Project Name: 9101 Highland

Description: Revised special land use approval and final site plan approval

RE: 9101 Highland Road-Proposed Commercial Development- Final Site Plan/Final Engineering Plan Review – 3rd Review

Final Site Plan / Special Land Use Review for White Lake Charter Township, Michigan

SCALE: 1" = 30' PROJECT ID: DET-230229
TITLE: UTILITY & STORMWATER PROFILES
DRAWING: C-19

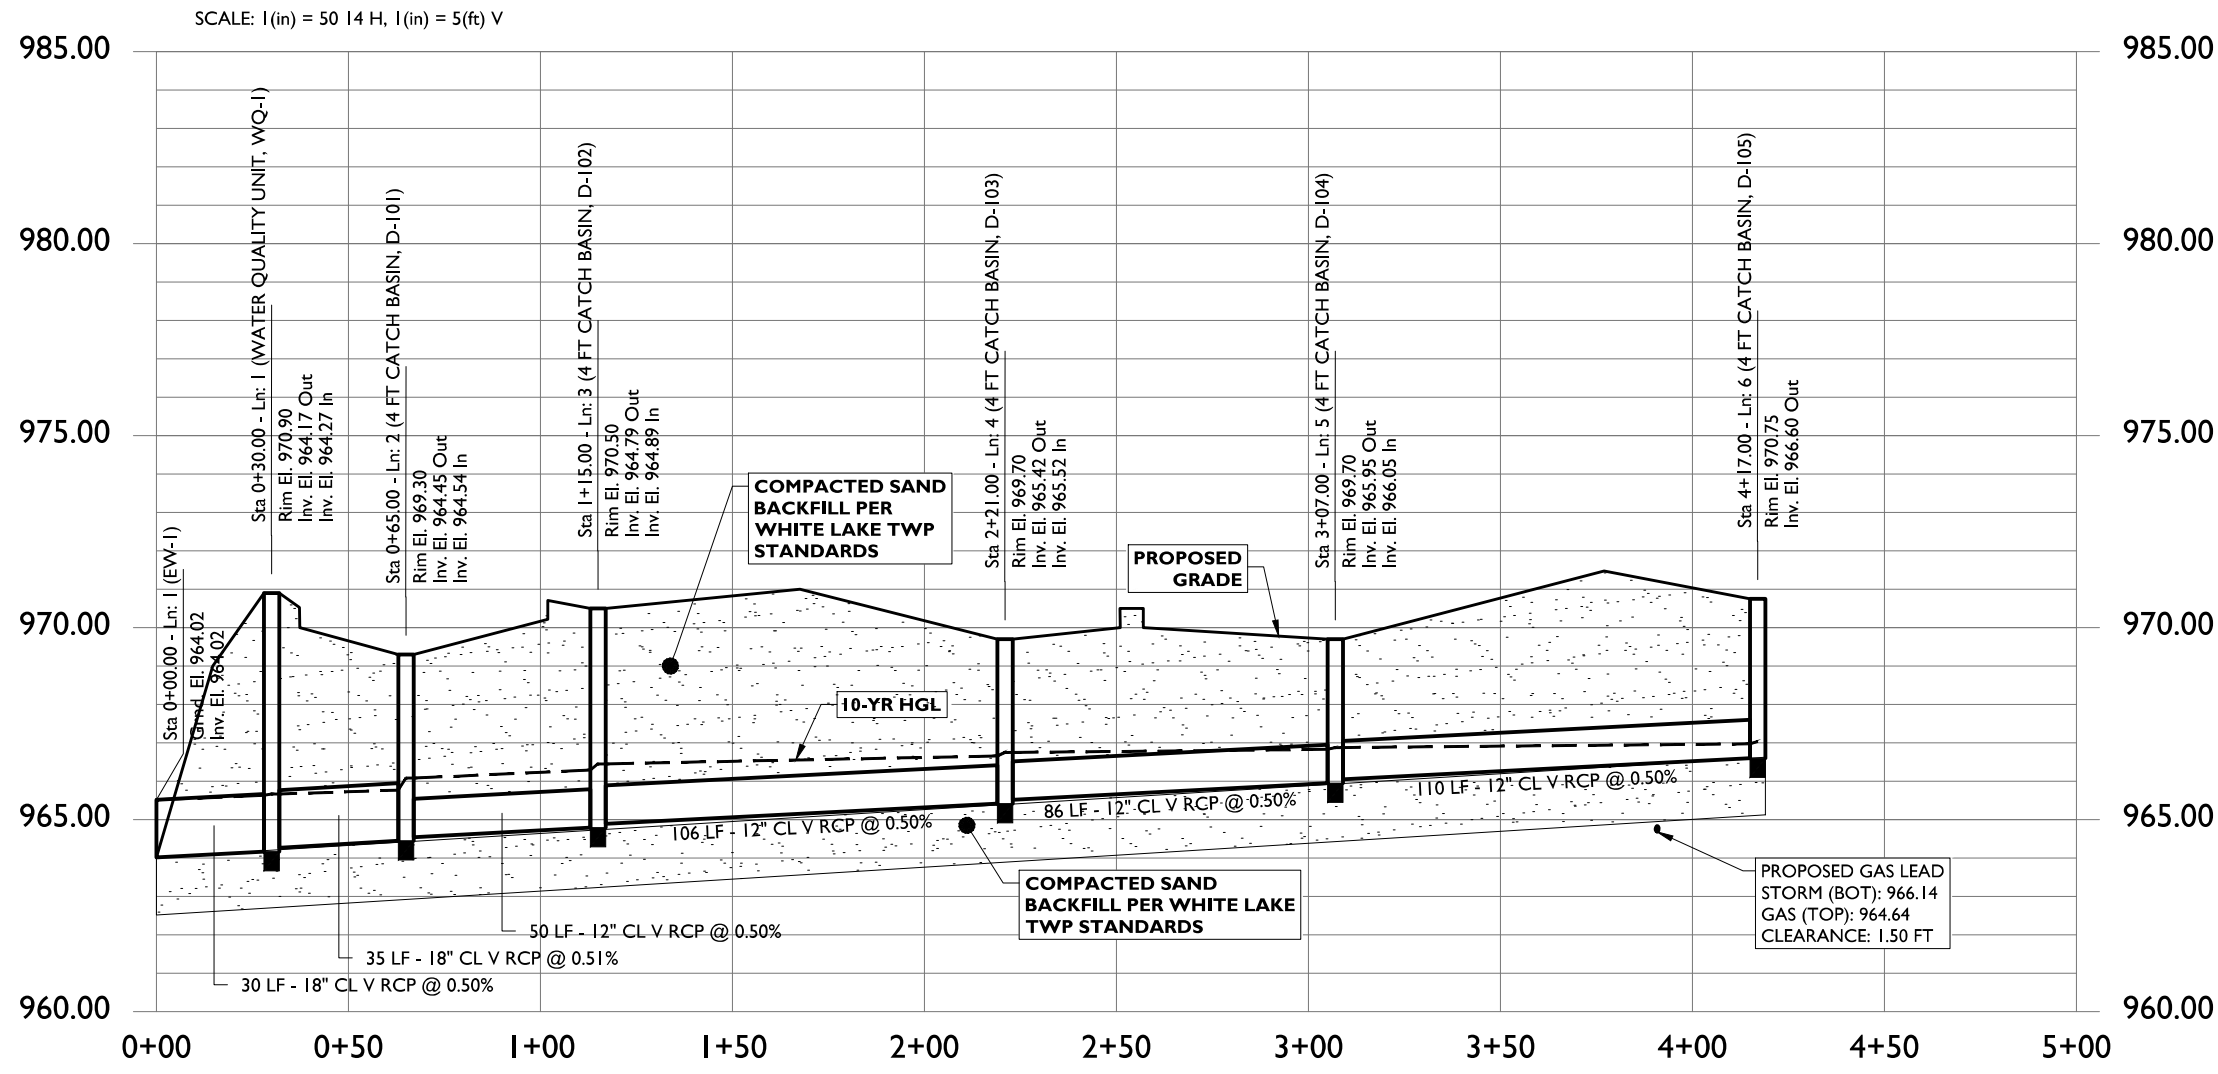
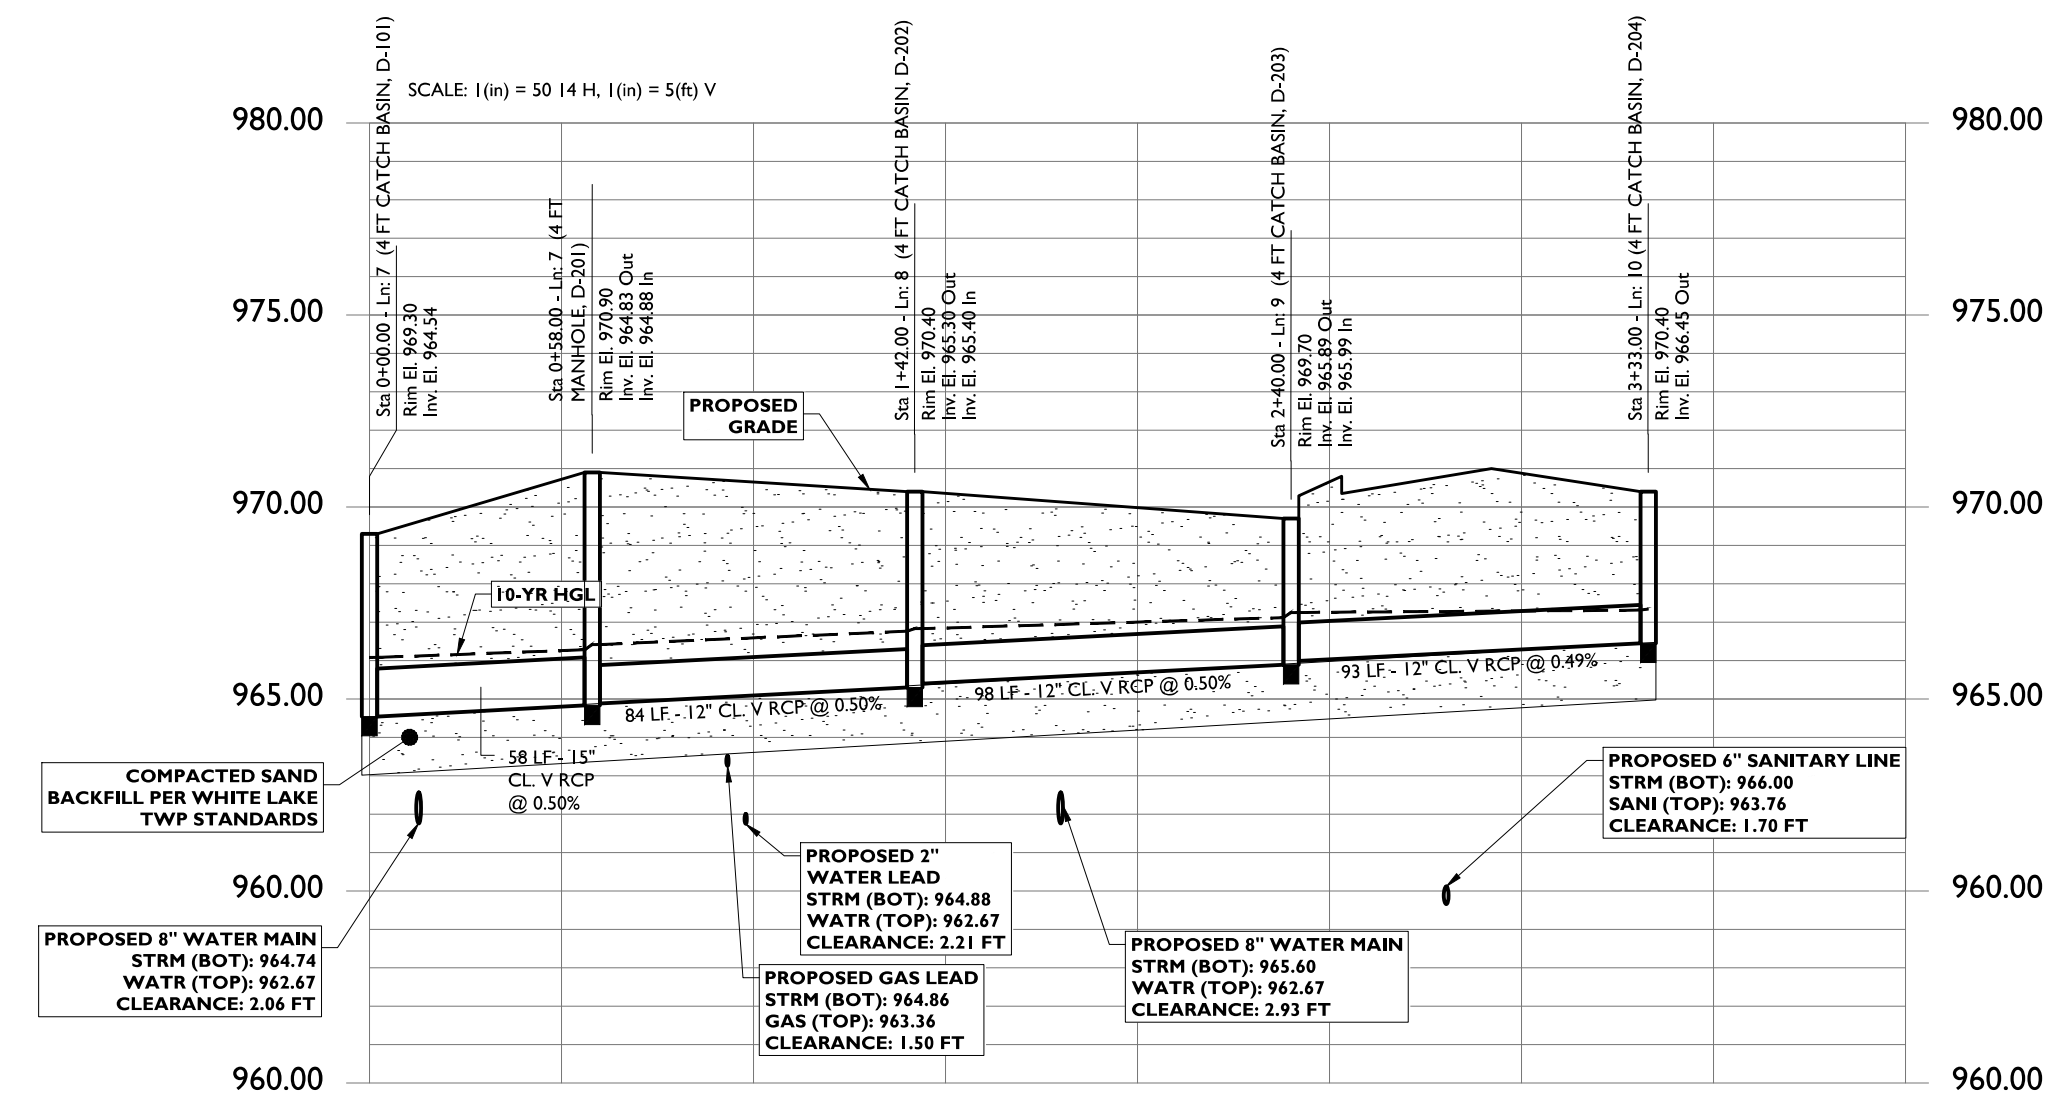
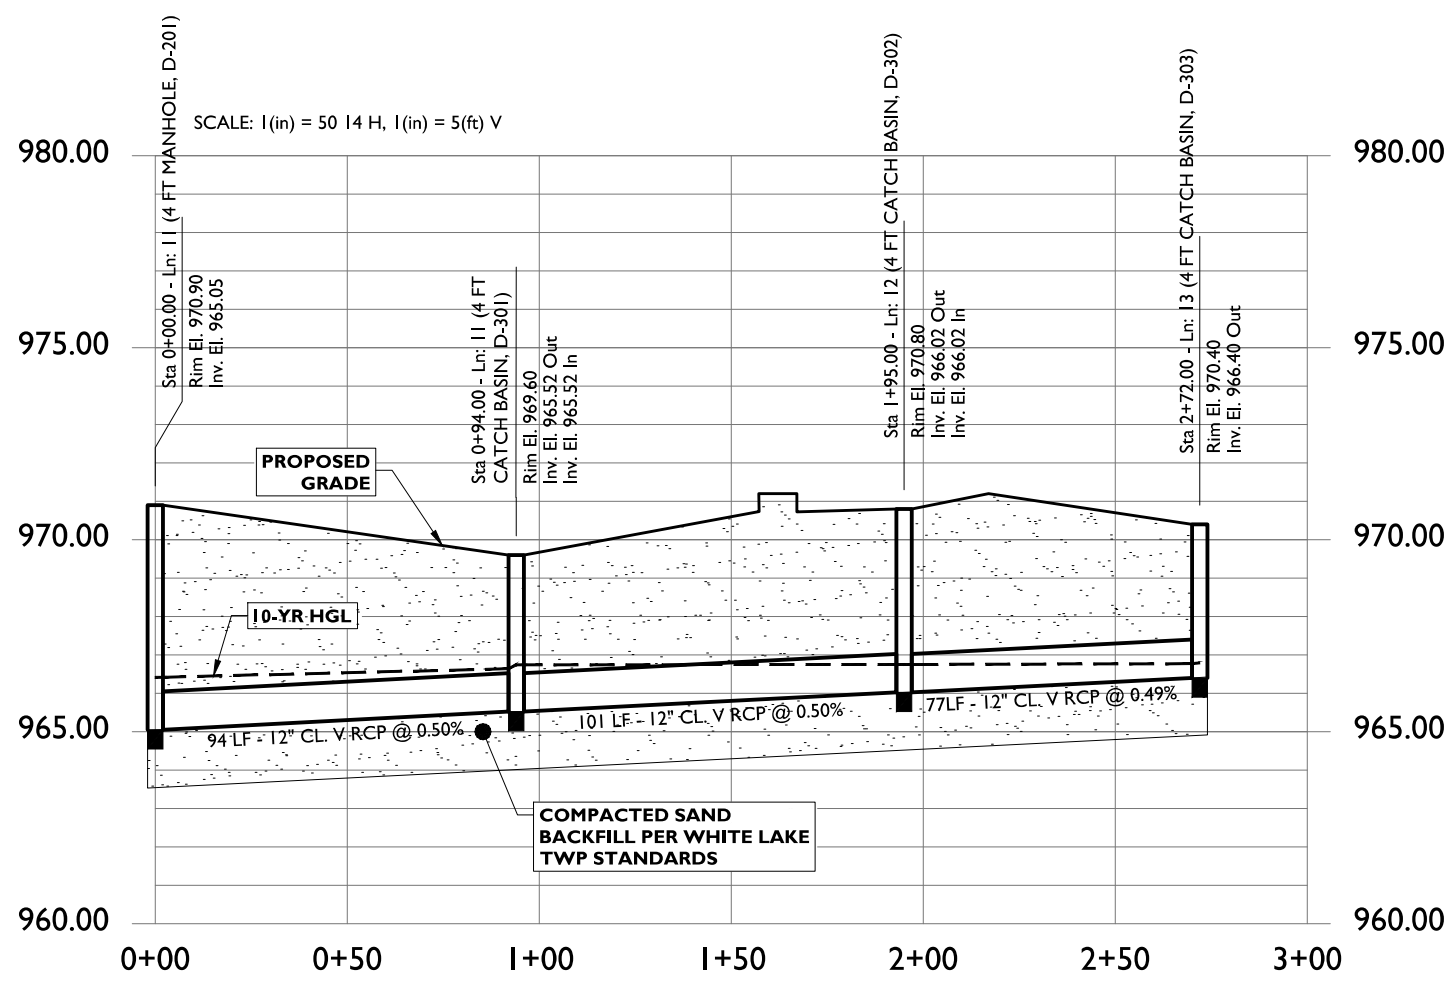
1. *Provide storm sewer profiles (including ES and partial profile of the basin) showing the following: 1) Pipe crossings (minimum 18" vertical separation); 2) Compacted sand backfill where needed; 3) Rim elevations; 4) Pipe length, slope, type of pipe, and diameter; 5) Invert elevations; 6) HGL 7) Diameter of all CBs and/or MHs-Note that minimum 48" diameter is required except for inlets where stormwater is discharged directly into a CB(these may be 24" diameter). Please check that plan and profiles match in terms of rim elevations, pipe lengths, slopes, etc....* **Comment partially addressed. The majority of information requested has now been provided; however, there are some revisions required to the profiles. Please see attached red lined Sheet C-19.**

13. *Sheet C-8- Provide crossing information where the storm sewer and water line cross just north of storm MH D-201. Comment outstanding. Watermain crossing is shown on storm sewer profile; however, it is in incorrect location. Currently, it is shown on profile between Structures D-101 and D-201. The main should be between Structures D-201 and D-202.*
14. *Sheet C-18- HydroCAD Model- Correct 'Detention' to 'Retention.' This shall be corrected in two places. Comment outstanding.*
15. *Sheet C-18- Stormwater System Design (10-Year Storm)- There are several items on here which shall require revision. Please see snippet on red lined profiles sheet for comments. Comment outstanding.*

FLOOR PLAN - WEST BUILDING
SCALE: 1/8" = 1'-0"

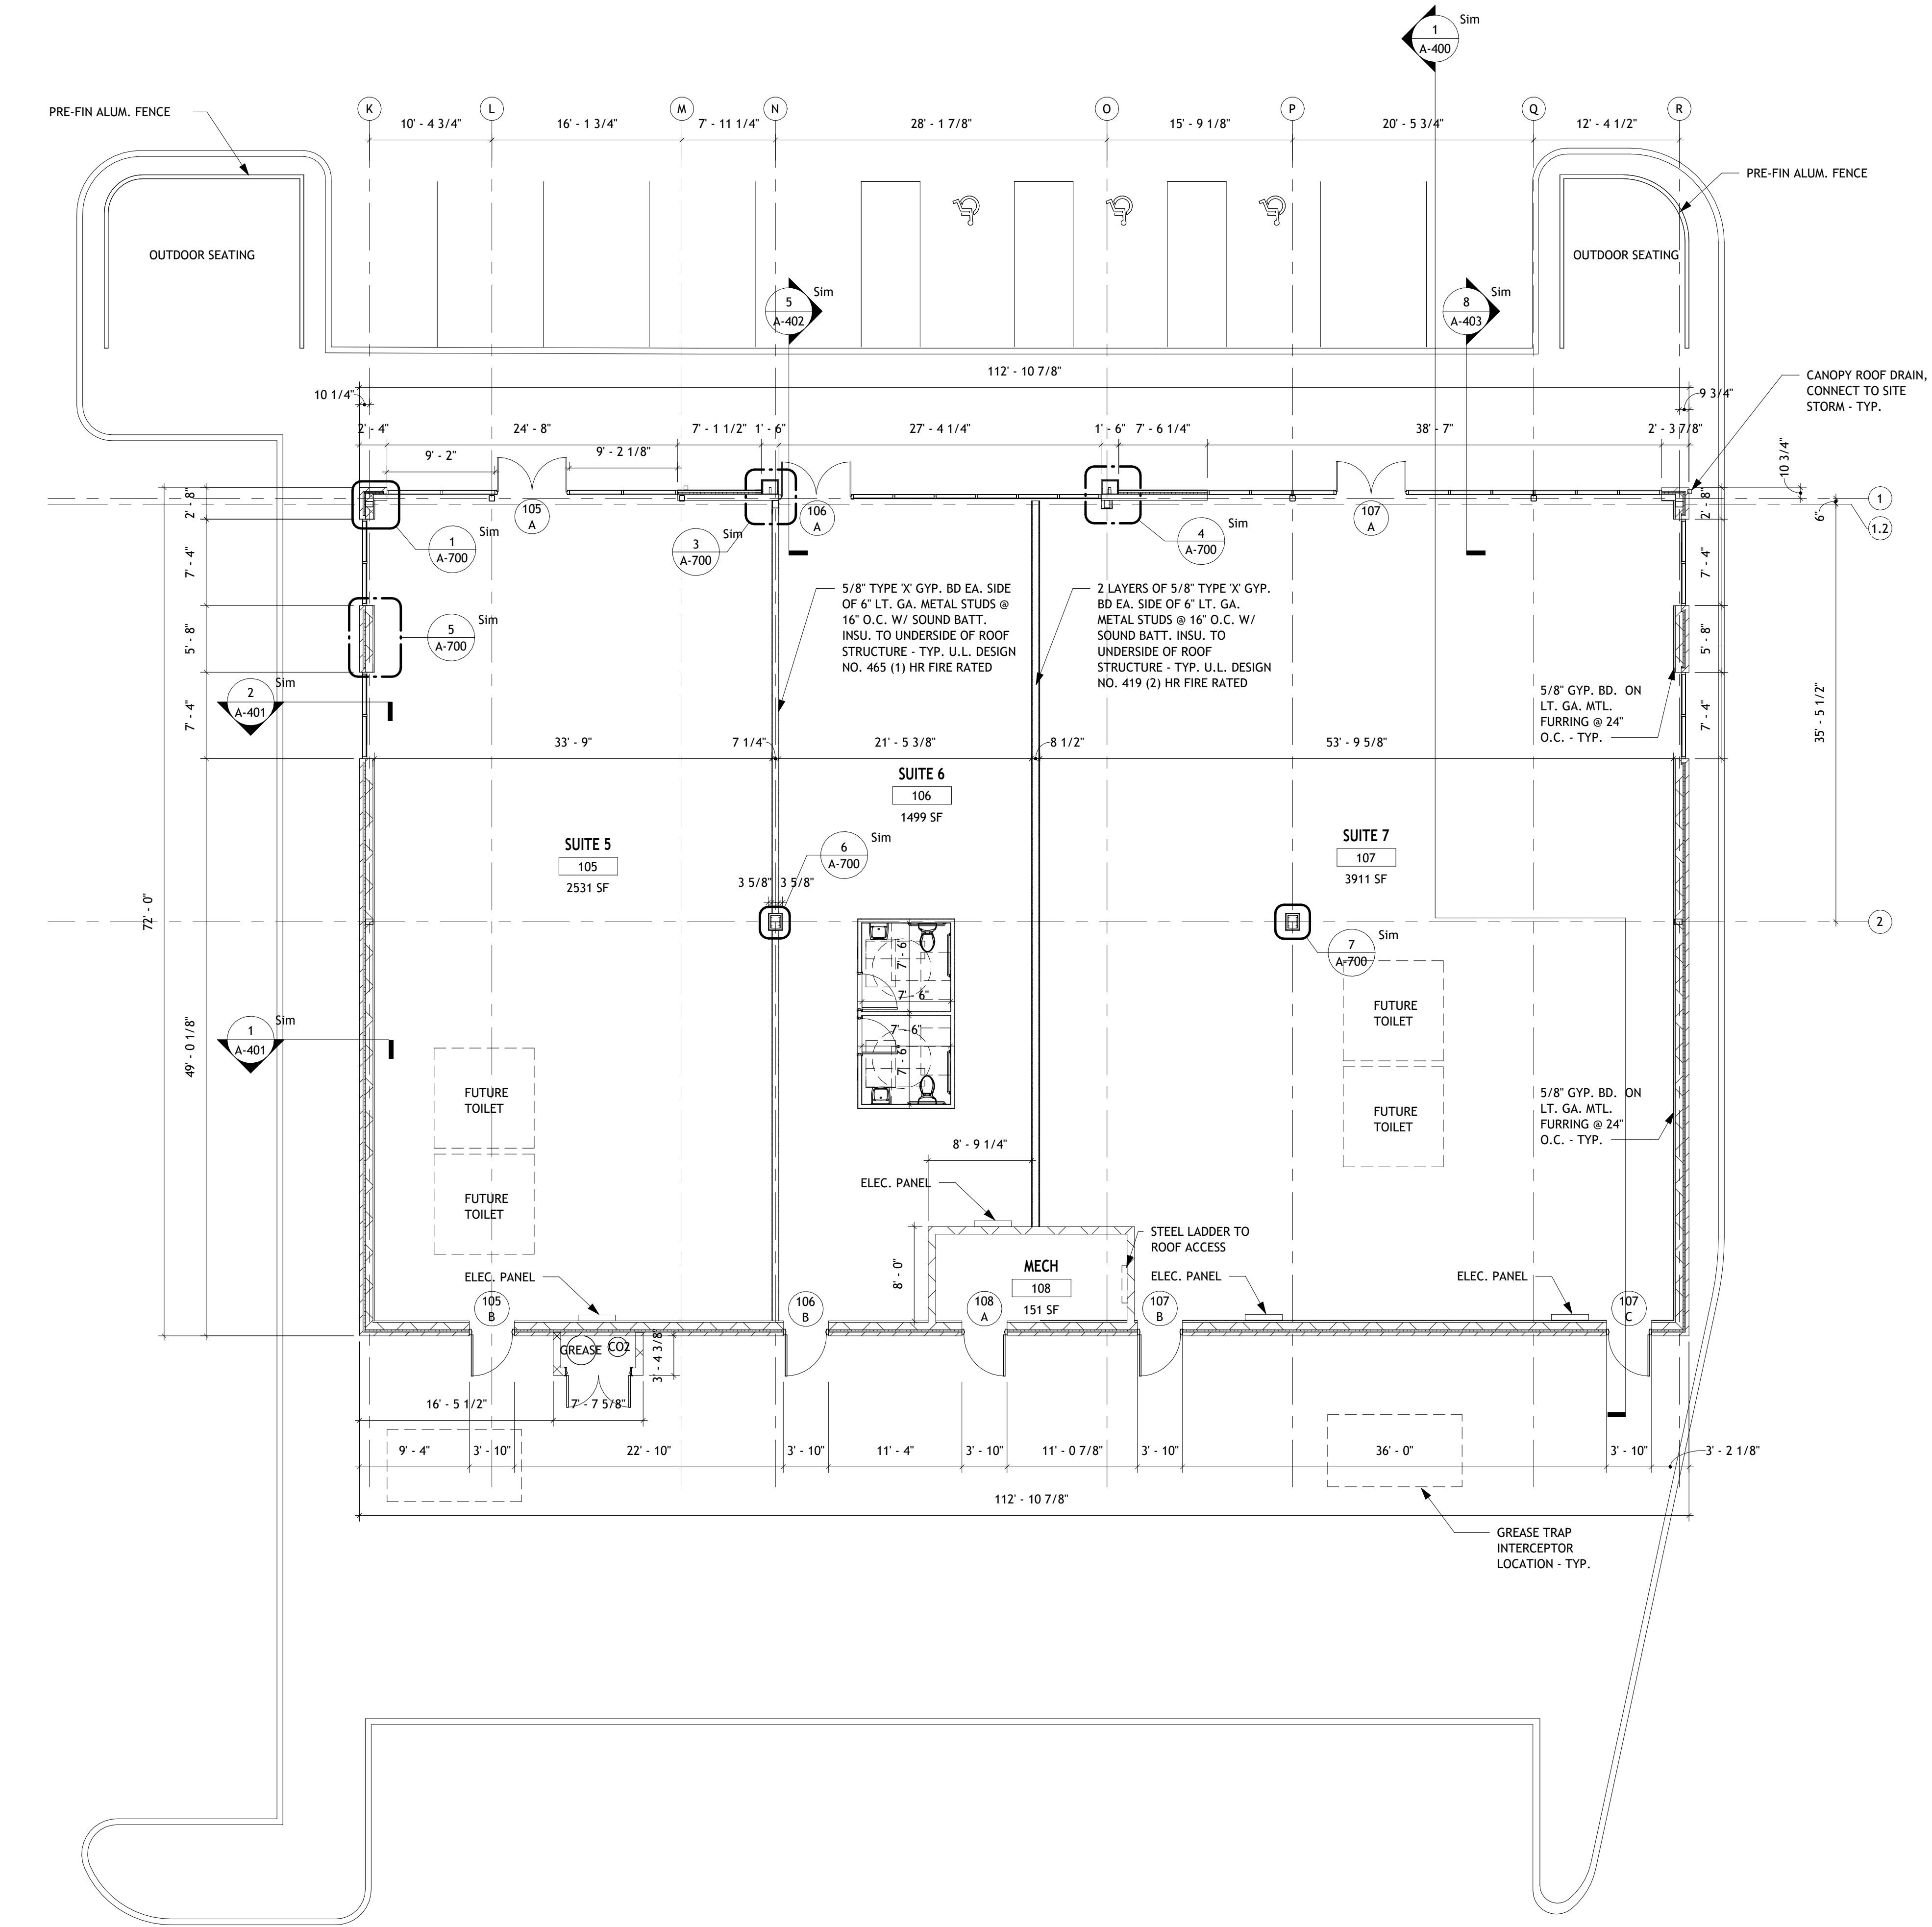
Sheet A-101 does not reflect the modified patio layout for the east building and should be updated.

Items to be Addressed: 1.) Color renderings and sample boards are required for Planning Commission review. 2.) Sheet 101 should be updated to reflect revised east building patio layout.
